Rezoning Transportation Analysis

Petition Number: 2023-002

General Location Identifier: 23107120

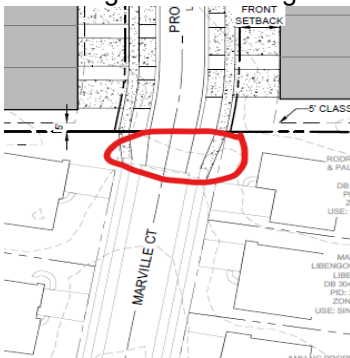
- a. ~~McKee Road: Future location of curb and gutter to be 30 feet from roadway centerline to accommodate the Charlotte Streets Map with a roadway typical section of 4+ Avenue.~~

~~NOTE: Additional distance from center line to back of curb may be required in locations where a median is present or around intersections and interchanges.~~

~~Label and dimension the curb and gutter from the centerline for each road on the site plan.~~
